U.S. Department
of Transportation
**Federal Highway
Administration**

We have completed a review of the STA-US30-18.35, PID 20344, FEIS Reevaluation Document submitted May 23, 2007. The FEIS Reevaluation is approved as submitted. If there are any changes to the environmental commitments or the preferred alternative, please advise us so we can verify that the FEIS Reevaluation is still appropriate.

STA-30-18.35
FINAL ENVIRONMENTAL IMPACT
STATEMENT REEVALUATION
PID 20344

**STA-30-18.35, PID 20344
FINAL ENVIRONMENTAL IMPACT
STATEMENT REEVALUATION**

Figure 5

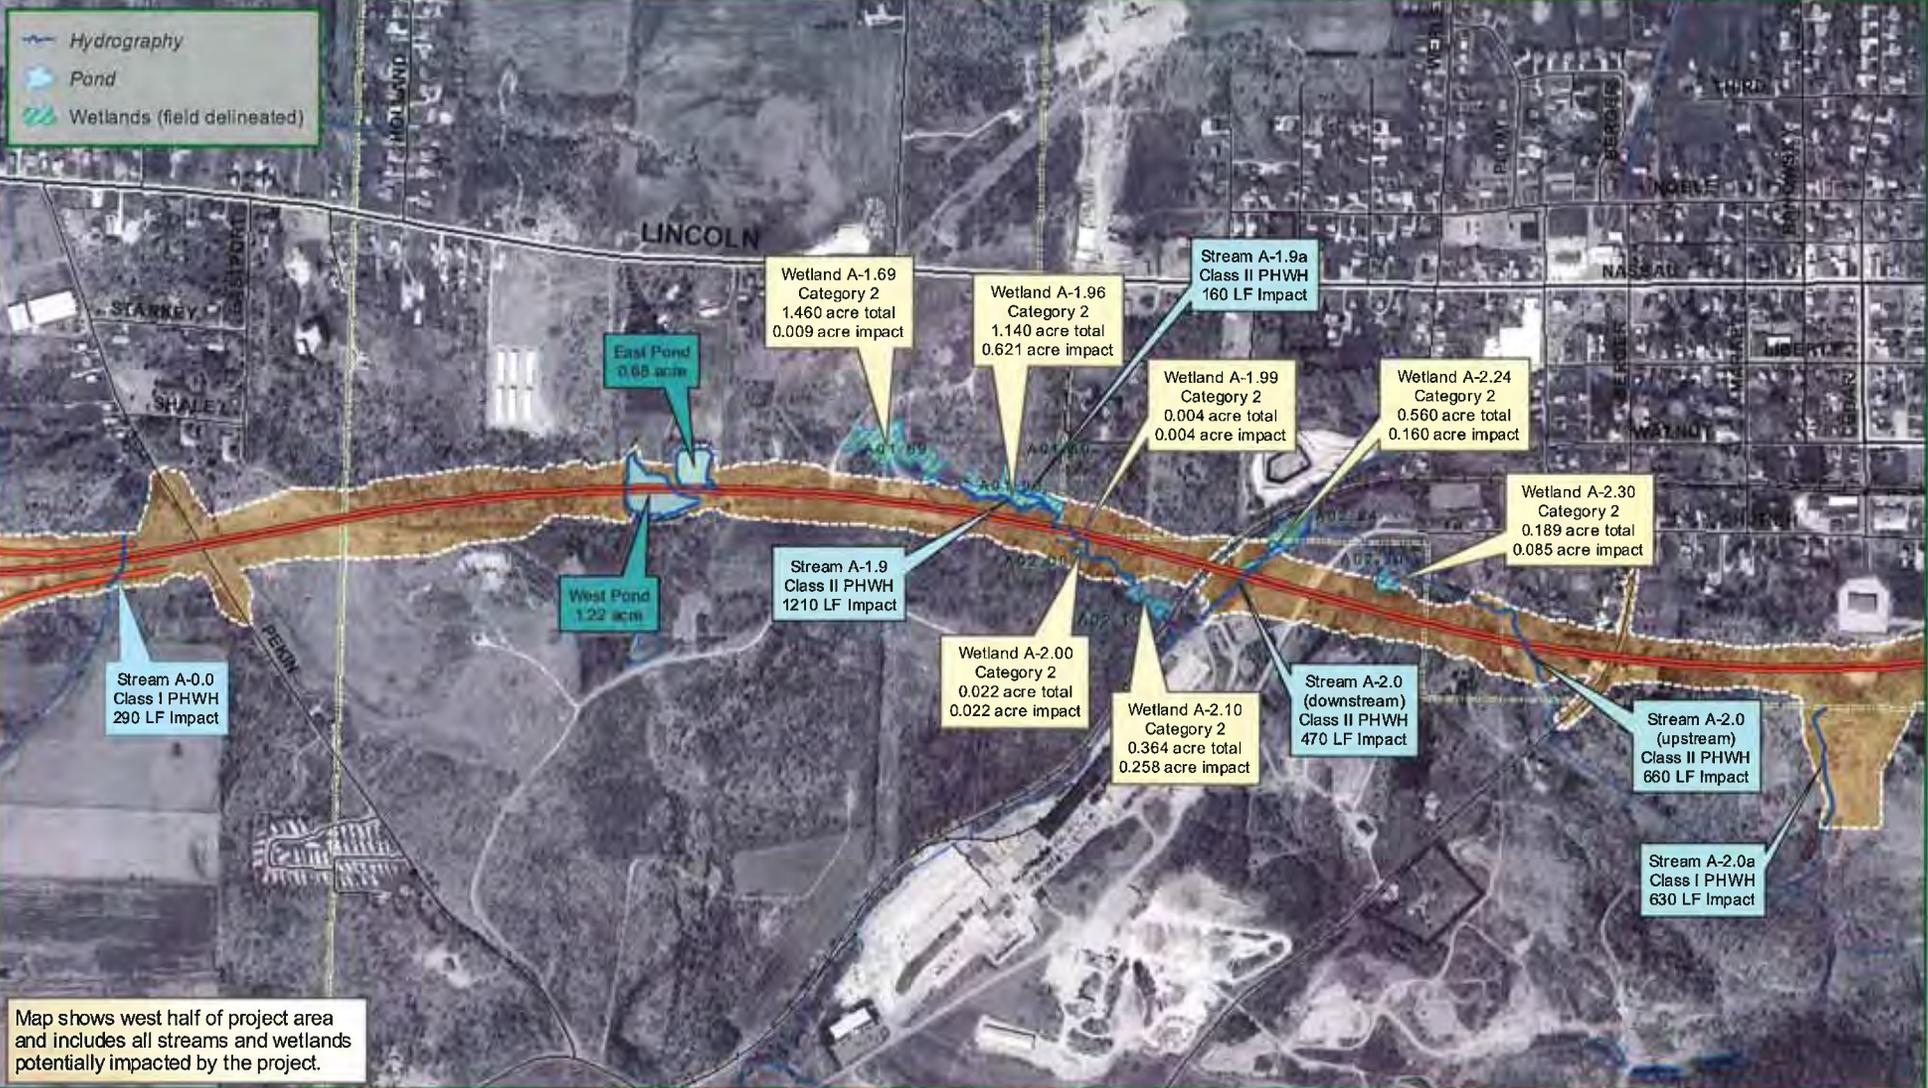
- **U.S. Fish and Wildlife Service, 09/23/05** – The following USFWS comment concerned streams:
 - Streams and wetland avoidance - Streams and wetlands should be avoided, and practicable alternatives that avoid water resources should be considered. *(To the degree feasible, impacts on streams and wetlands have been minimized.)*

- **Ohio Environmental Protection Agency, 09/23/05** – The following comment concerned ponds:
 - Ponds in the project area – Were biological surveys done for the two impacted ponds? Will there be compensation for these resources? *(No biological surveys were completed for the two ponds. The ponds appear to provide the typical habitats normally found in “farm ponds.” Because these ponds provide water for livestock, methods to replace the water source are being evaluated.)*

- **U.S. Fish and Wildlife Service, 09/23/05** – The following USFWS comment concerned wetlands:
 - Streams and wetland avoidance - Streams and wetlands should be avoided, and practicable alternatives that avoid water resources should be considered. *(To the degree feasible, impacts on streams and wetlands have been minimized.)*

Figure 6

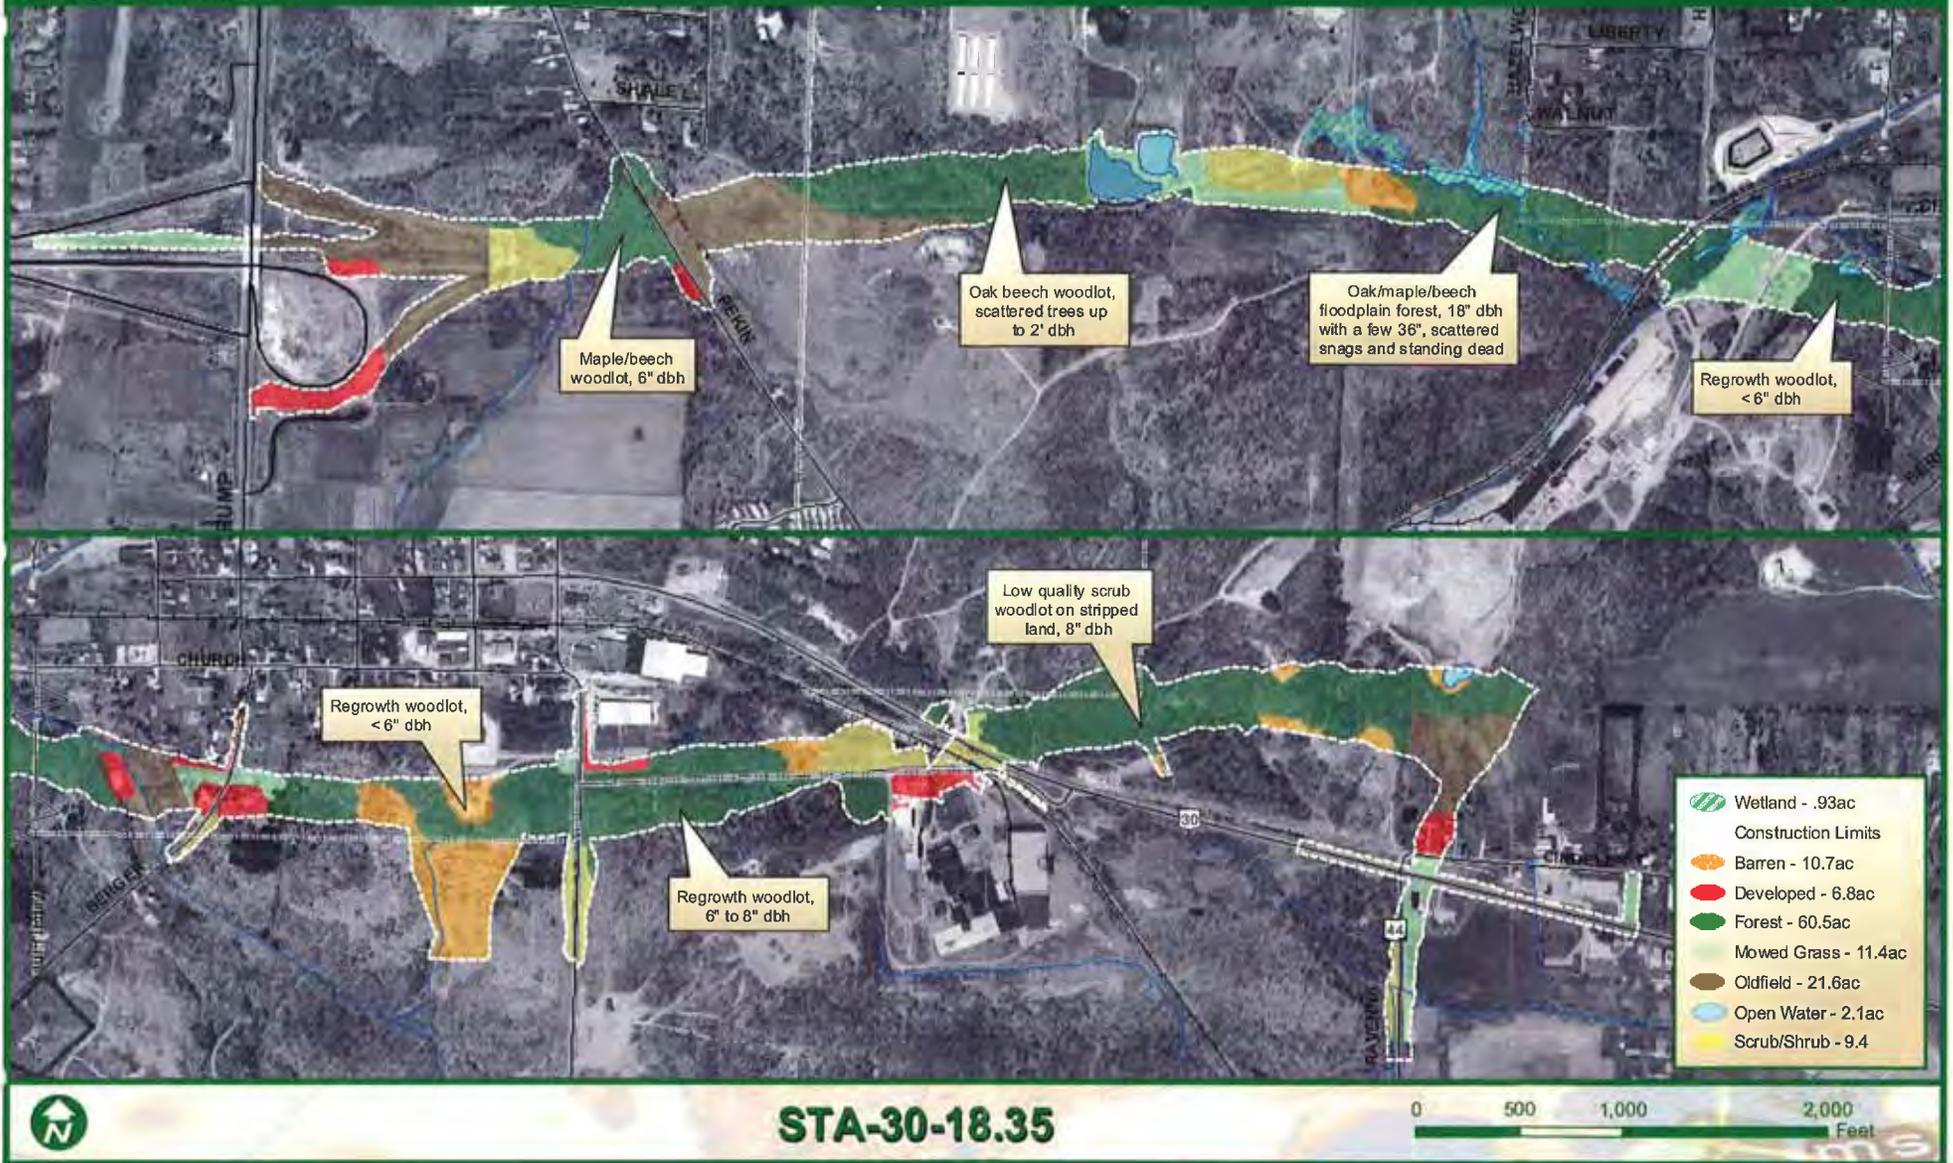
- **Ohio Environmental Protection Agency (09/23/05)** – The following comment concerned terrestrial habitat:
 - Impacts to terrestrial habitat – The project will impact forested, terrestrial and upland communities. Will these impacts result in significant degradation of the environment? (*It is recognized that the project will impact terrestrial habitats. Because of the urbanized nature of the project area, the project will not result in any substantial fragmentation of large forest tracts or the disruption of major forest corridors.*)
